Appendix 1

Figure 10: Stormwater management spatial diagram.

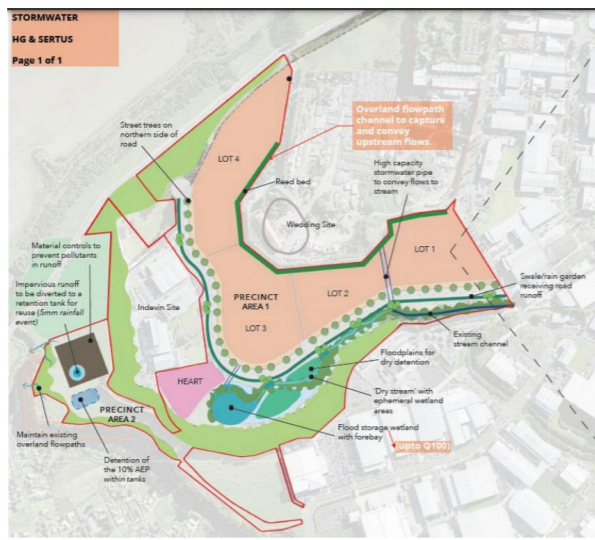
It is also recommended that any visual modelling of future development within the proposed precinct should remove the existing pines near Oruarangi Creek, as they are aging and seem incompatible with the revegetation and 'naturalising' of the creek margins and lower tuff slopes suggested in the lodged landscape and visual effects assessment (Figures 9 and 10 below).

3	Masterplan – effects on natural features and landscapes in the precinct	Please provide further information explaining the correlation between the indicative high-level masterplan and precinct plan 4 regarding the no build area's spatial extent and protection of the crater rim landform from earthworks and development.	2	<p>The indicative high-level masterplan (figure 9 in the lodged landscape and visual effects assessment and referenced in further information item 1(b) above) shows an area of land within the proposed precinct accommodating stormwater ponds / wetland, revegetation and open space, but this is larger than the 'no build area' shown on Precinct Plan 4 for Sub-Precinct.</p> <p>Furthermore, the lodged landscape and visual effects assessment also states on page 13 that the "masterplan identifies the crater rim landform to be protected from earthworks and development". As this is not readily apparent when cross-referencing the masterplan with Precinct Plan 4, further clarification is also sought in this regard</p>	The Masterplan referenced on page 13 of the Landscape and Visual Assessment (LVA) prepared by Boffa Miskell reflects the outcomes of the master planning exercise undertaken with Mana Whenua prior to the preparation of the plan change. The master plan does not include any 'no build areas' rather provides a high-level indication of how the site could be laid out and key structuring elements such as the internal access arrangements and planted areas. These areas have been refined through the preparation of the plan change, including through the identification of 'no build', 'no excavation', landscape buffers surrounding the Pā, vehicle access restrictions and the stormwater / flood storage basin as outlined on Precinct Plans 3 and 4.

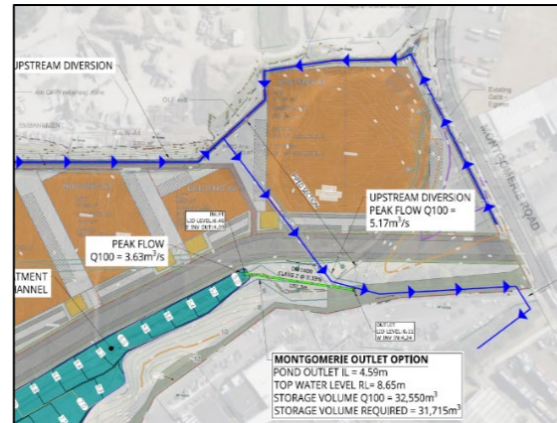
Please clarify whether the Montgomerie outlet will be replaced by an open channel as per the plan below, or whether it is planned to upgrade the existing 1200mm dia culvert and also clarify how the peak 1% AEP flow rate of 8.53m³/s will be conveyed to the open channel downstream

(c) Piping of creek/open channel

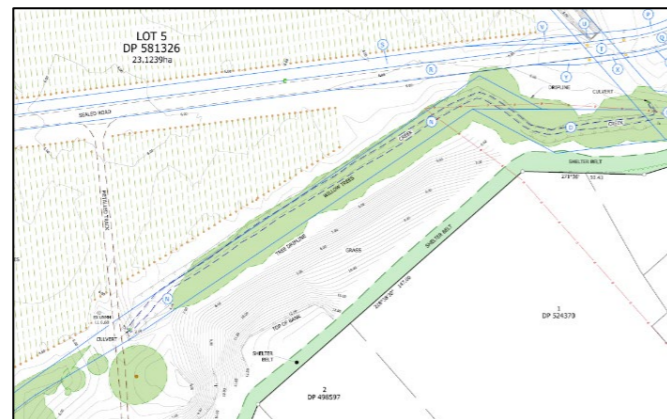
As per the survey plans and shown below, it appears that there is an existing creek along the south-eastern boundary of the site. Please clarify whether piping of the existing creek is intended as part of development proposed within the plan change area.

Please refer to Sertus' RFI responses summarised in **Attachment 4** to the applicant's reply and updated Stormwater Management Report in **Attachment 5** to the applicant's reply.
